**Pendleton Office**

**Addendum #2**

Pendleton Office  
Addendum No. 2  
Date: August 11, 2025

**Date:** 08/08/25  
**Client:** SRA  
**Project:** Pendleton Park  
Hemphill, Texas  
**Project No.:** 21.095

SHEET NUMBER  
A301

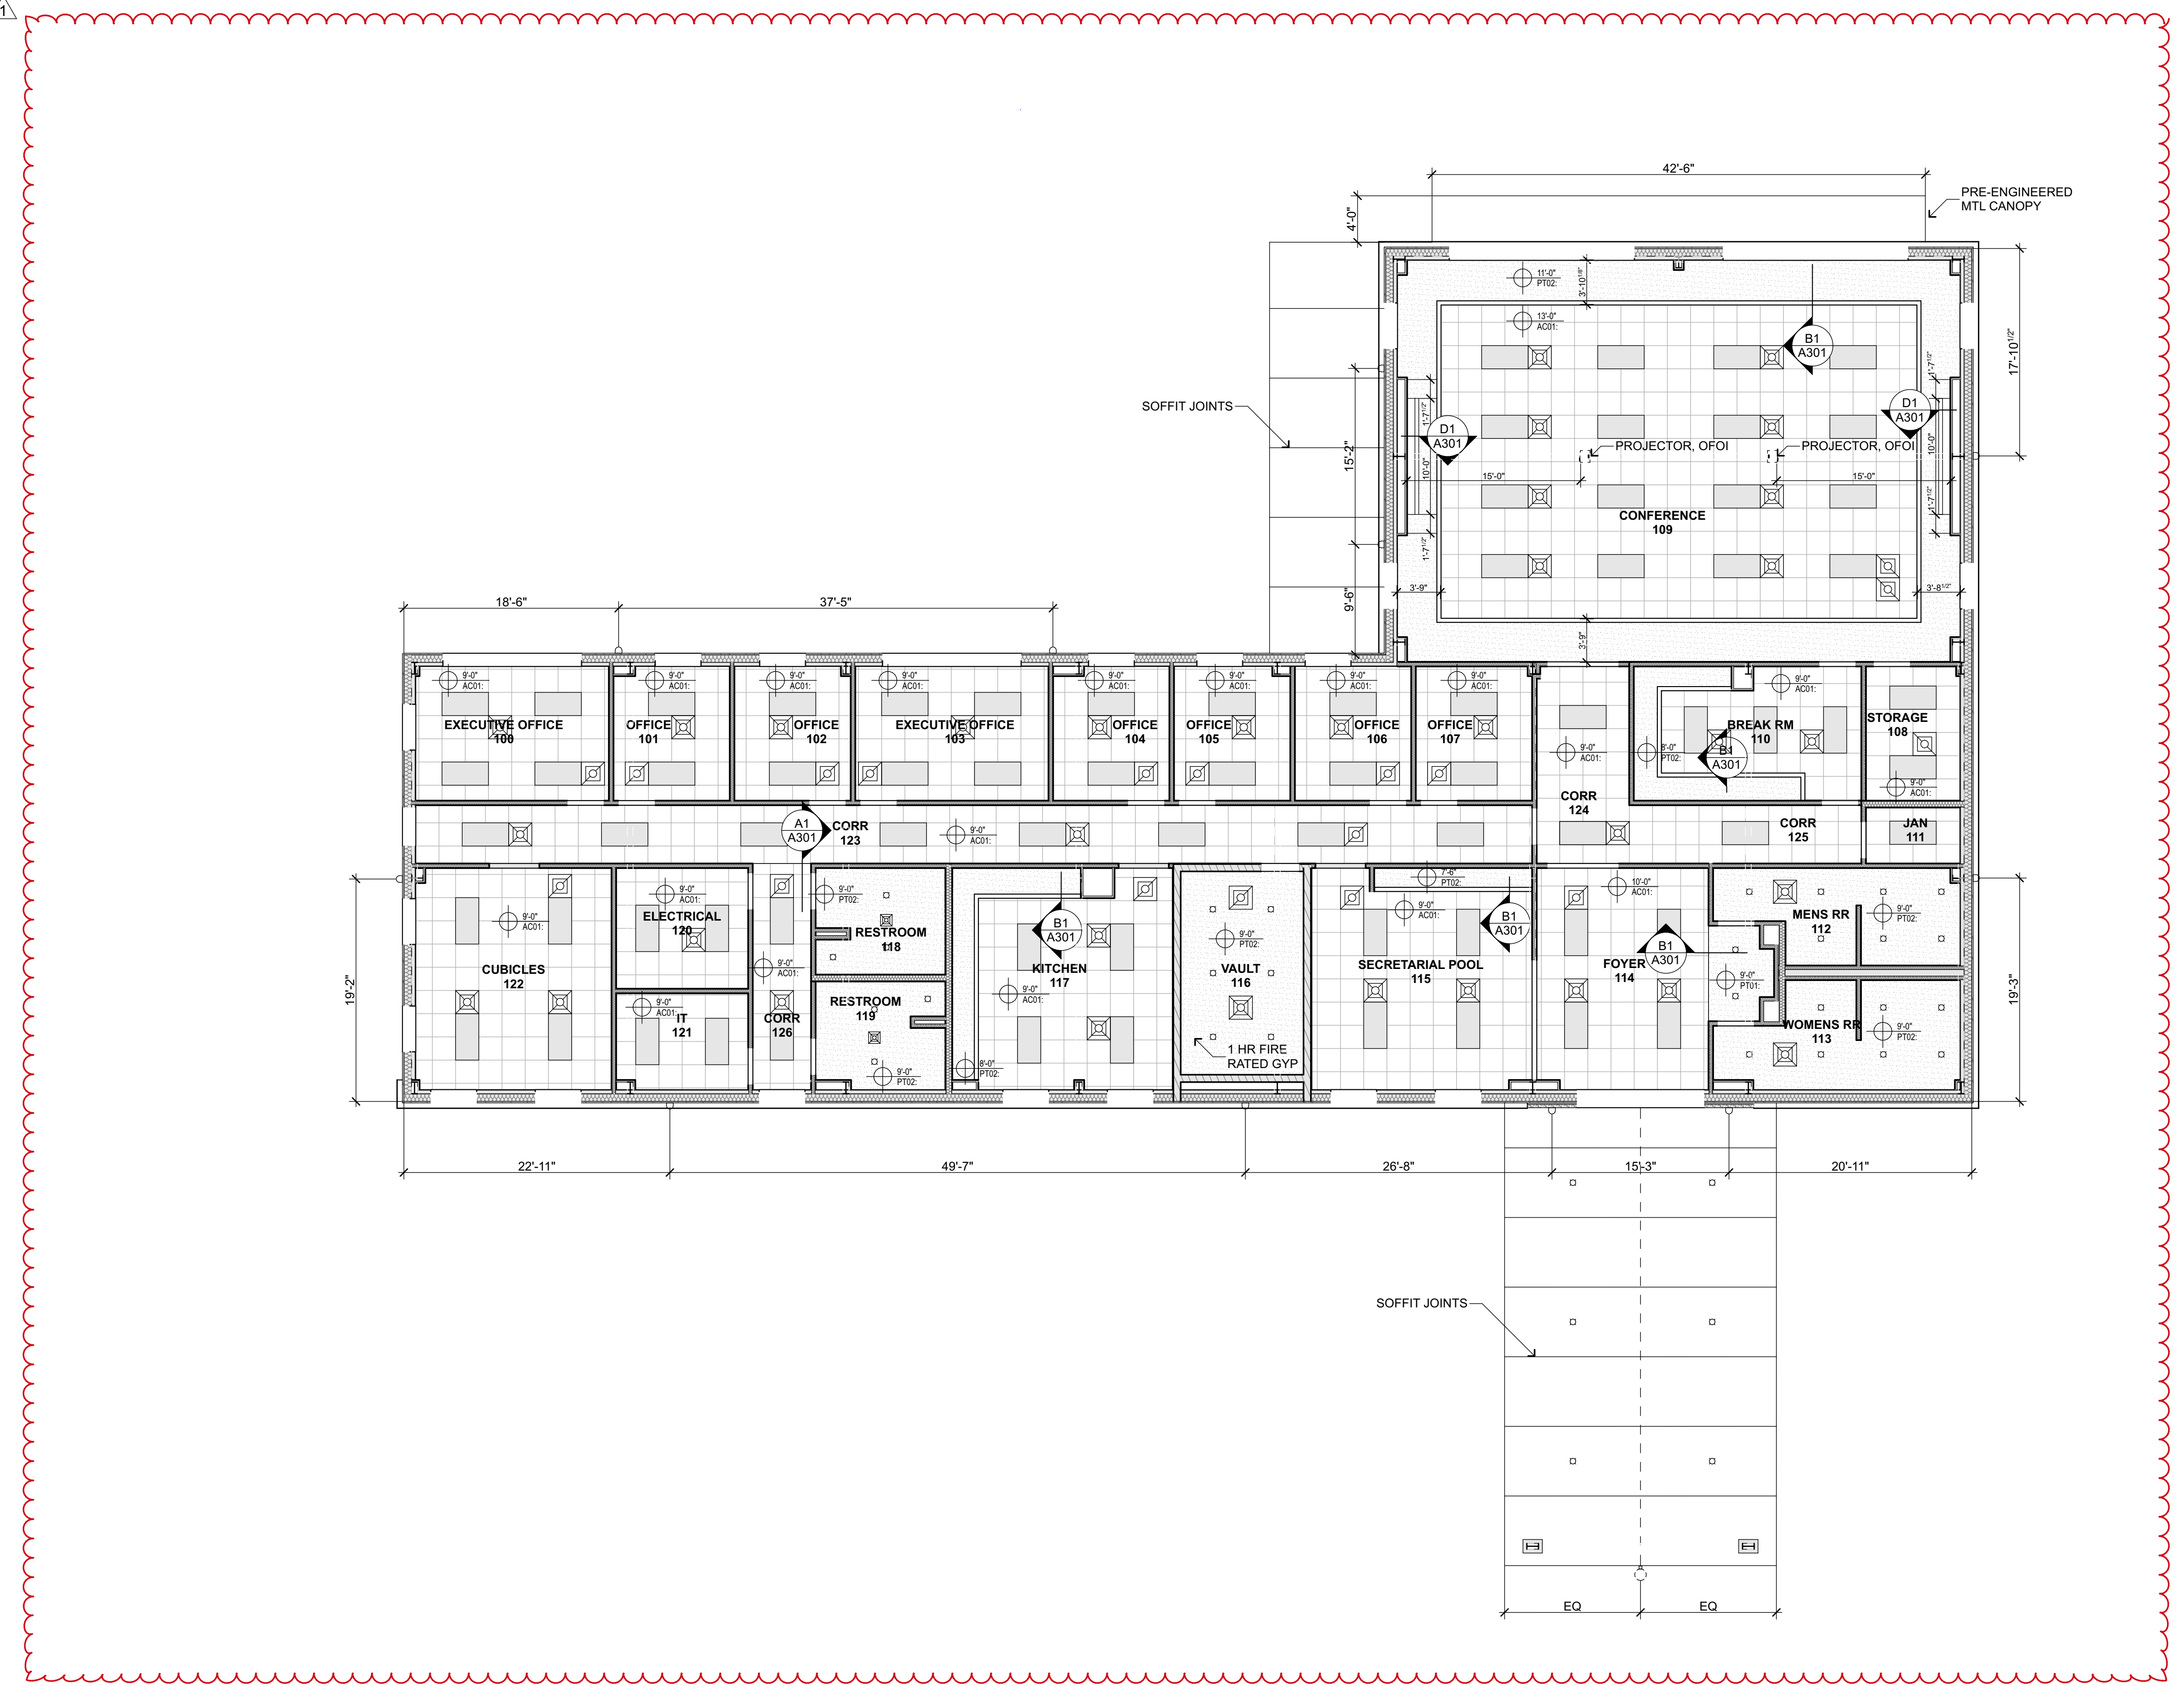
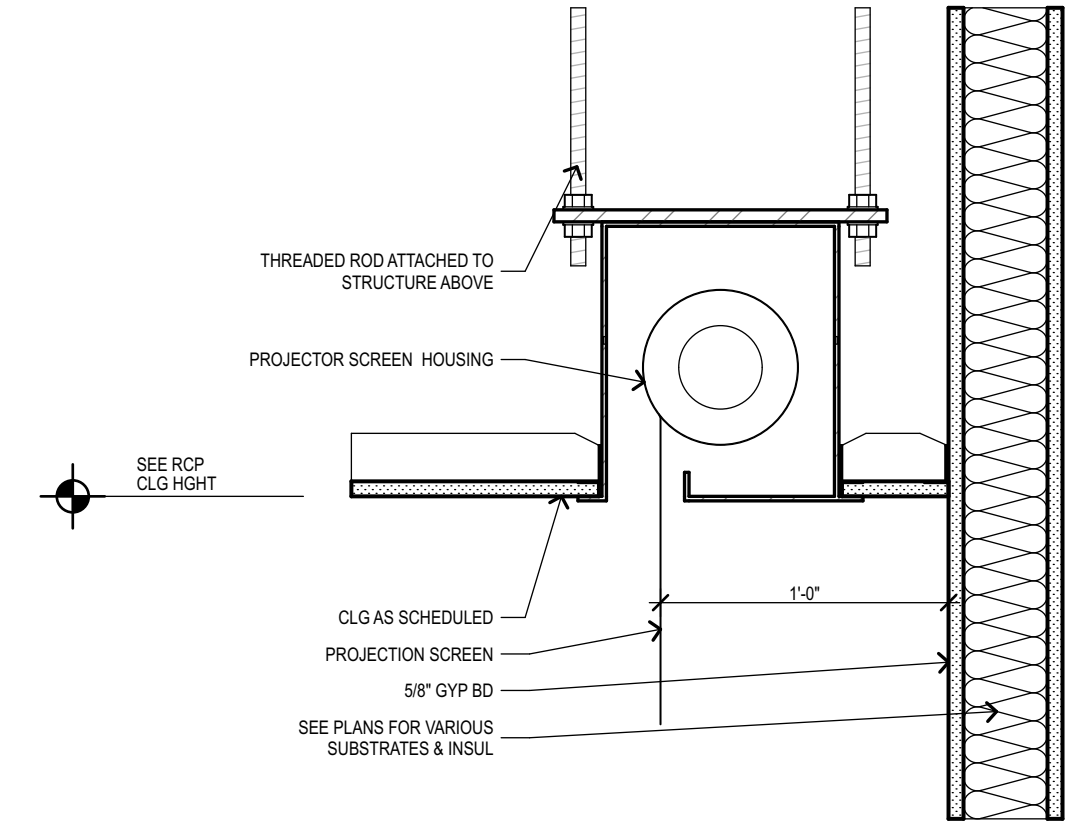
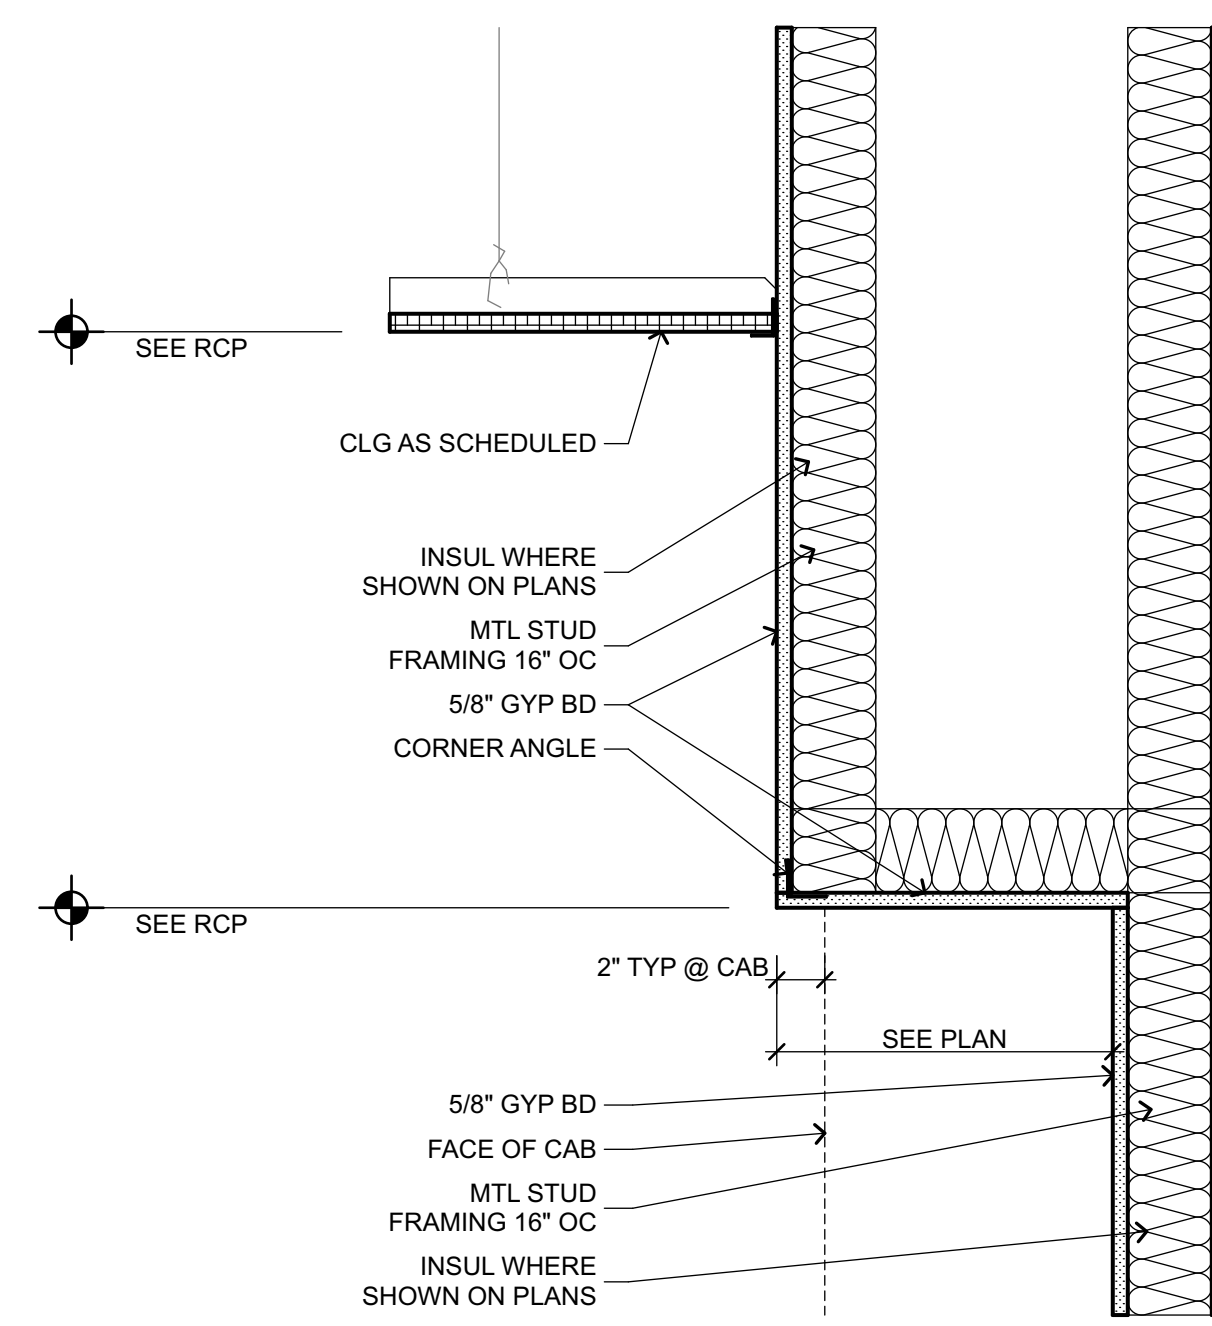
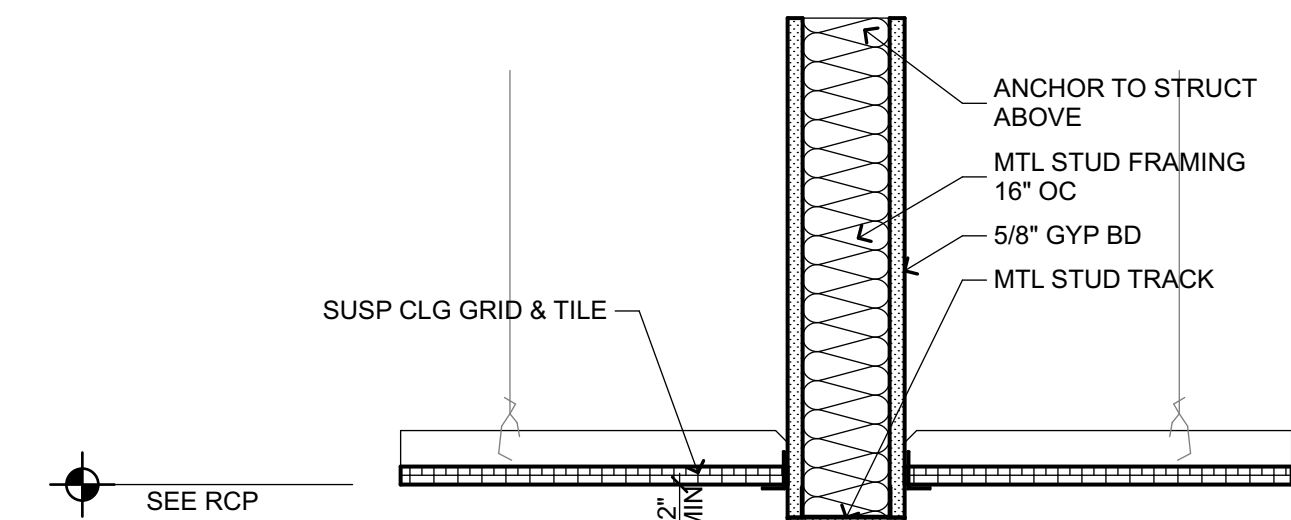
ITEM 1.05. A301 – REVISION Gyp ceiling paint revised.
